Meeting Minutes

Project Name: Wood Residence

Date of Meeting: 6/5/2026

- **Primary Wardrobe** – see attached markups and notes on the shop drawing

SHEET: A12
 DRAWN BY: SJB
 PLAN: MAIN LEVEL
 PRIMARY WARDROBE
 REVISIONS: 1 JUNE 26

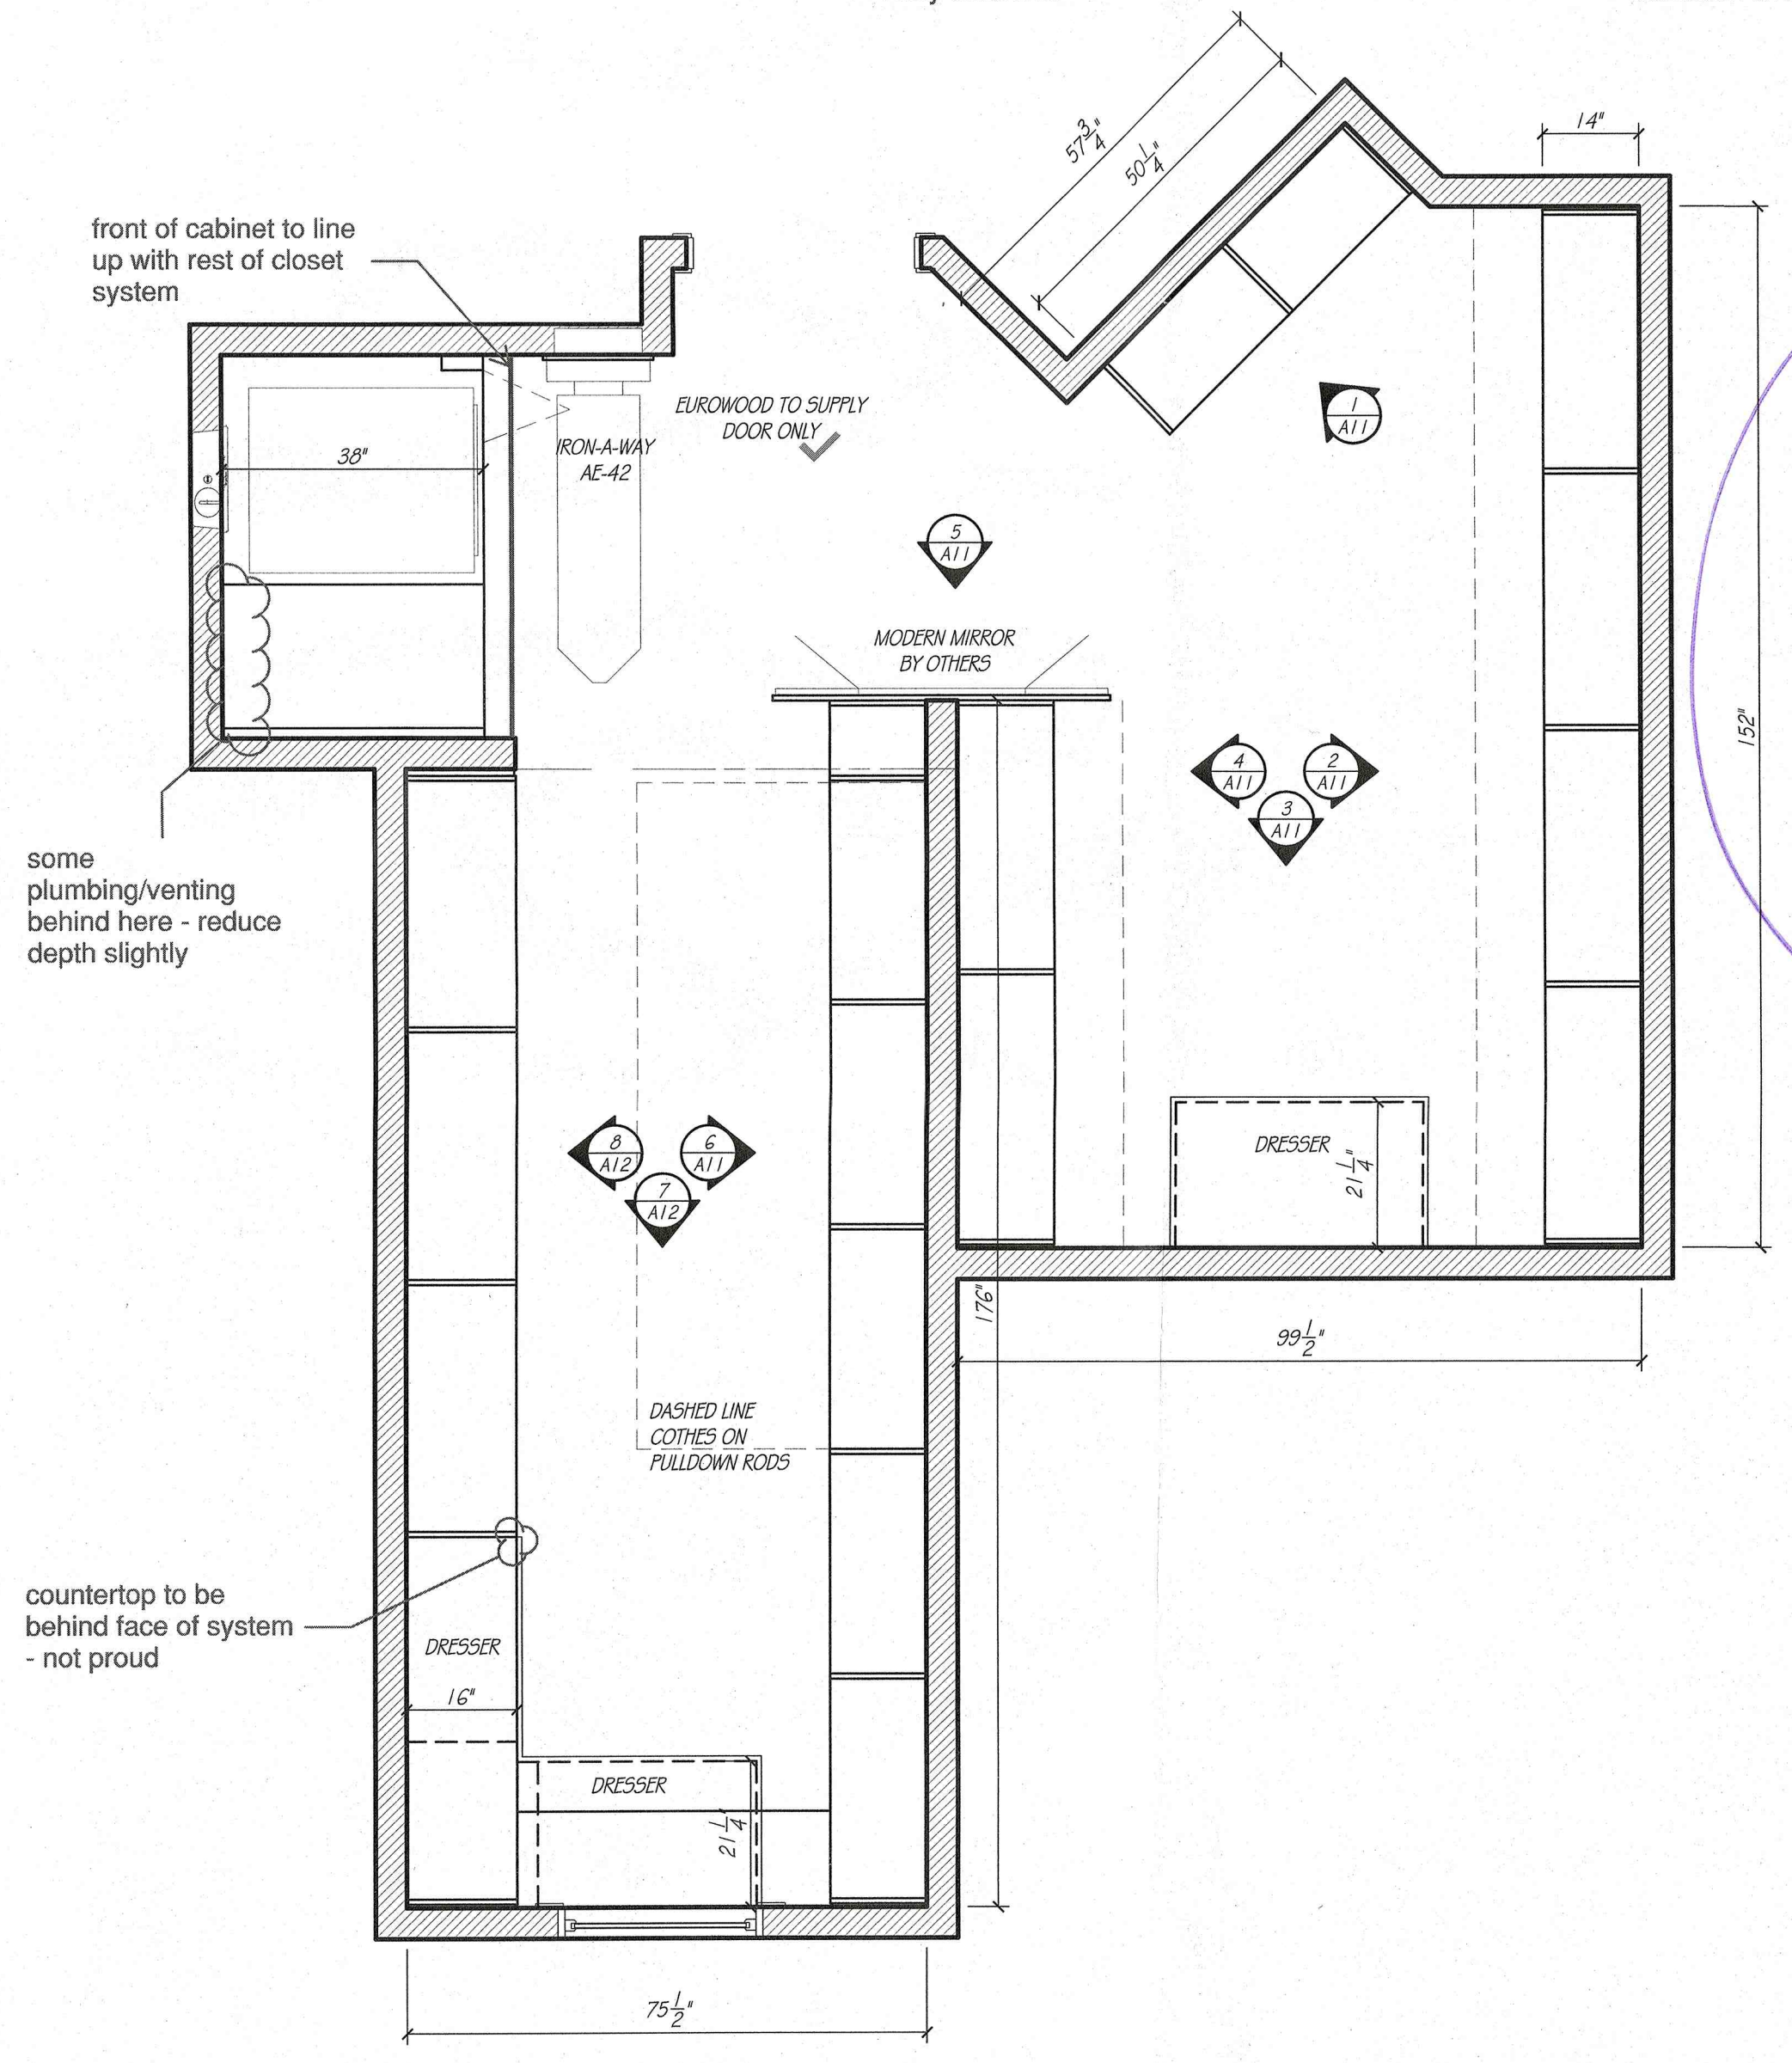
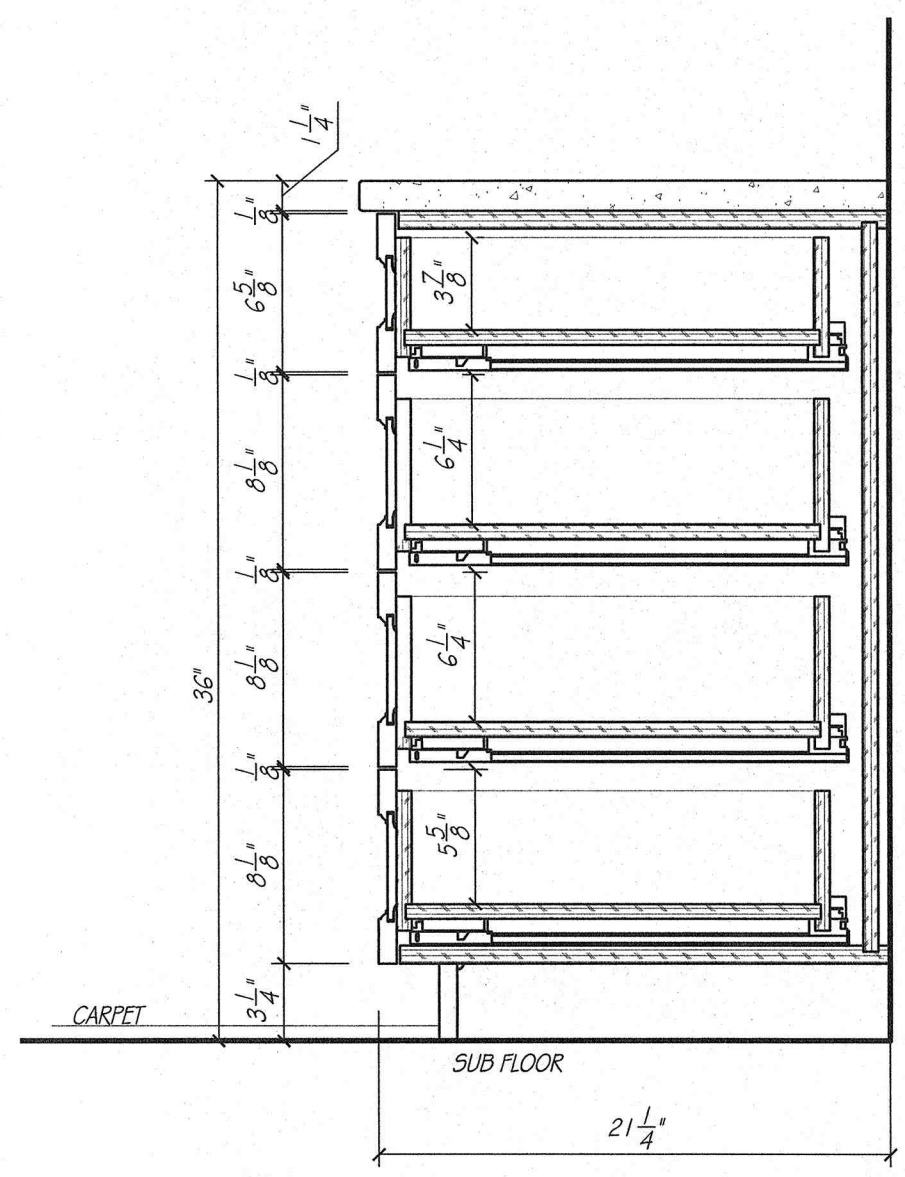
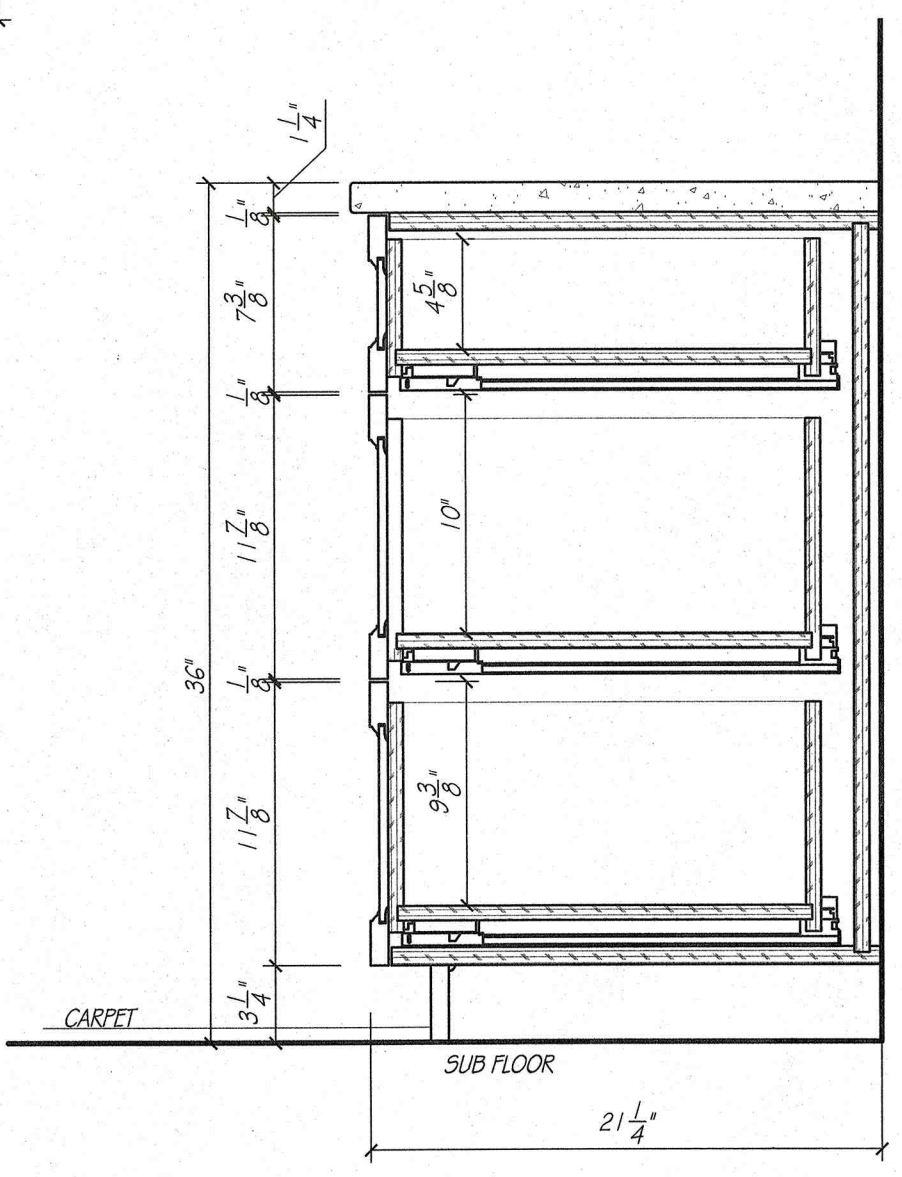
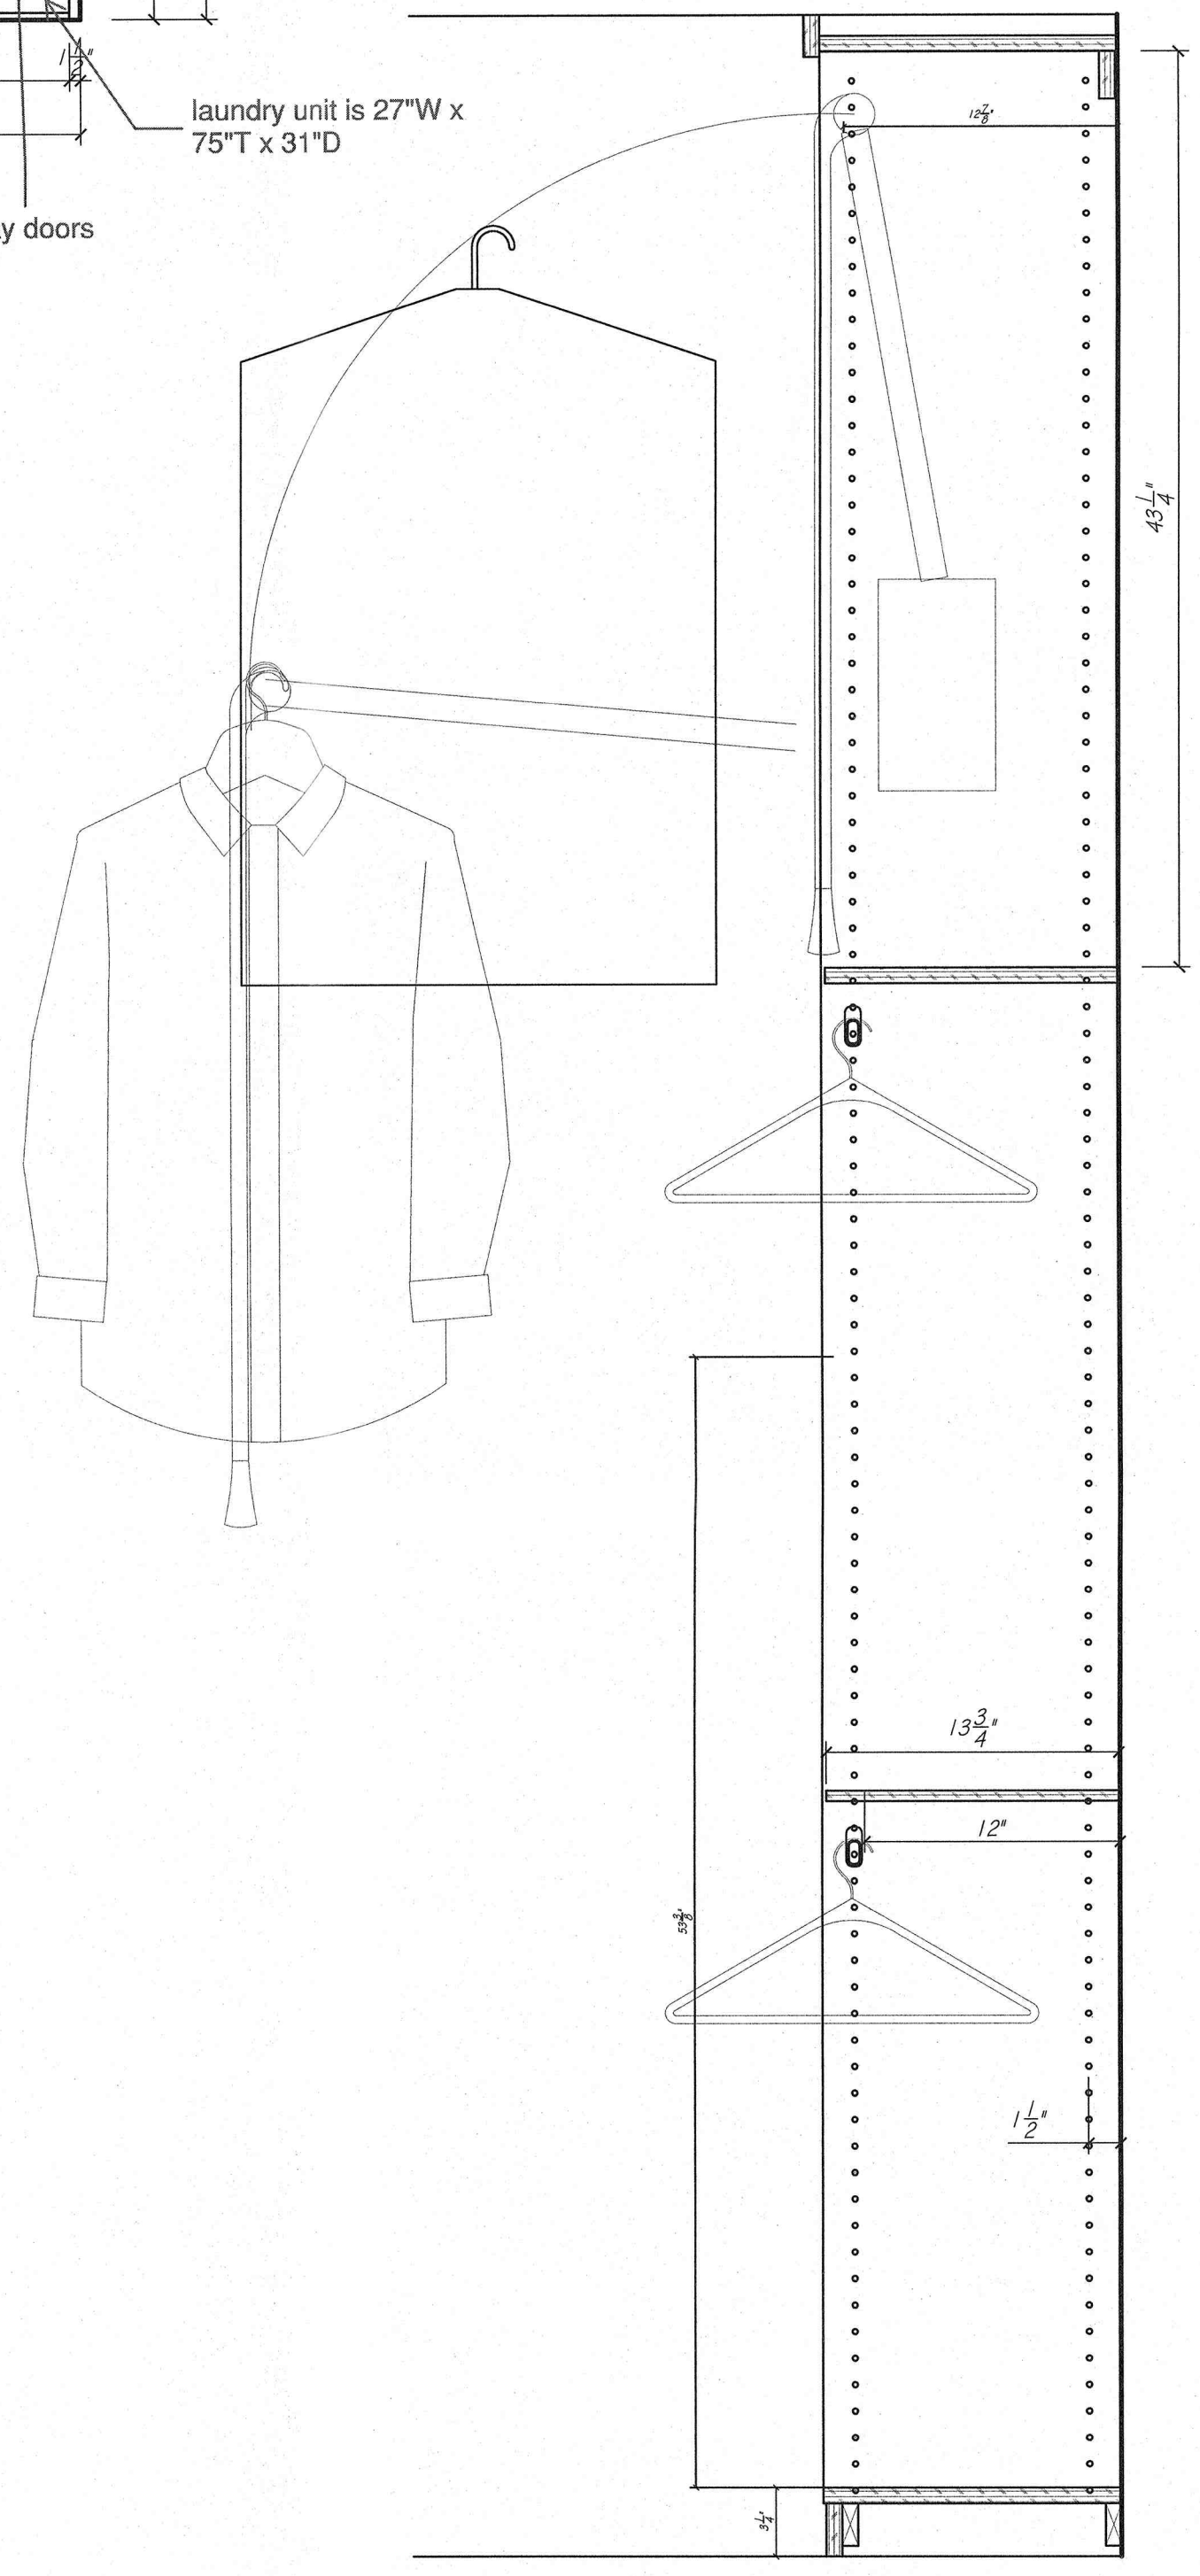
*TRANSFERRED
 SPECS
 ON MAIN
 CLOSET*

DRESSERS TO MATCH CABINERY FROM MASTER BATHROOM

*ADD WORKING
 UP SIDES OF
 RM SYSTEM*
